Access Compliance Report

Public Rights-of-Way

(Curb Ramps)

Intersection ID: 27418	Main Street: BALLANTYNE_COMMONS_PY	Cross Street: BALLANTYNE_TRACE_CT	Location: NE
ADA ID: 99F2FDD70F8C	Ramp Type: Perp	Initial Pass/Fail: Fail	Overall Compliance: No
Severity Score: 33.75			
Codes/Mitigation Info/Possible Solution		Field Measurements/Component Compliance

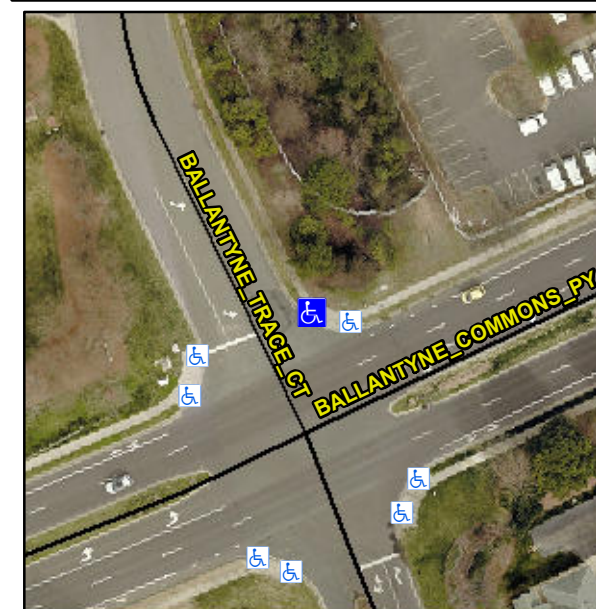
Not Found, R304.5.1, R304.5.3

Compliance	Description	Data	Compliance	Description	Data
N/A	Ramp Length (in)	96.0	Yes	Ramp Slope (%)	7.6
No	Ramp Width (in)	47.5	No	Ramp XSlope (%)	10.1
N/A	Flare Type LT	N/A	N/A	Flare Type RT	N/A
N/A	Flare Slope LT (%)	N/A	N/A	Flare Slope RT (%)	N/A
N/A	Flare Traversable LT?	N/A	N/A	Flare Traversable RT?	N/A
N/A	Landing Length (in)	N/A	N/A	DWS Provided?	N/A
N/A	Landing Width (in)	N/A	N/A	DWS Contrast?	N/A
N/A	Landing Slope (%)	N/A	N/A	DWS Length (in)	N/A
N/A	Landing X Slope (%)	N/A	N/A	DWS Full Width?	N/A
N/A	Landing Curb? (Y/N)	N/A	N/A	DWS Offset (in)	N/A
N/A	Shared Landing?	N/A			
N/A	Gutter Ponding?	N/A	N/A	Gutter Slope (%)	N/A
N/A	Gutter Lip Ht (in)	N/A	N/A	Gutter X Slope (%)	N/A
N/A	Painted X Walk1?	No	N/A	Painted X Walk2?	N/A
	X Walk 1 Direction	To SW		X Walk 2 Direction	N/A
N/A	X Walk 1 Width (in)	N/A	N/A	X Walk 2 Width (in)	N/A
	X Walk 1 Slope (%)	0.3		X Walk 2 Slope (%)	N/A
	X Walk 1 X Slope (%)	7.8		X Walk 2 X Slope (%)	N/A

Remove & Replace Entire Ramp.
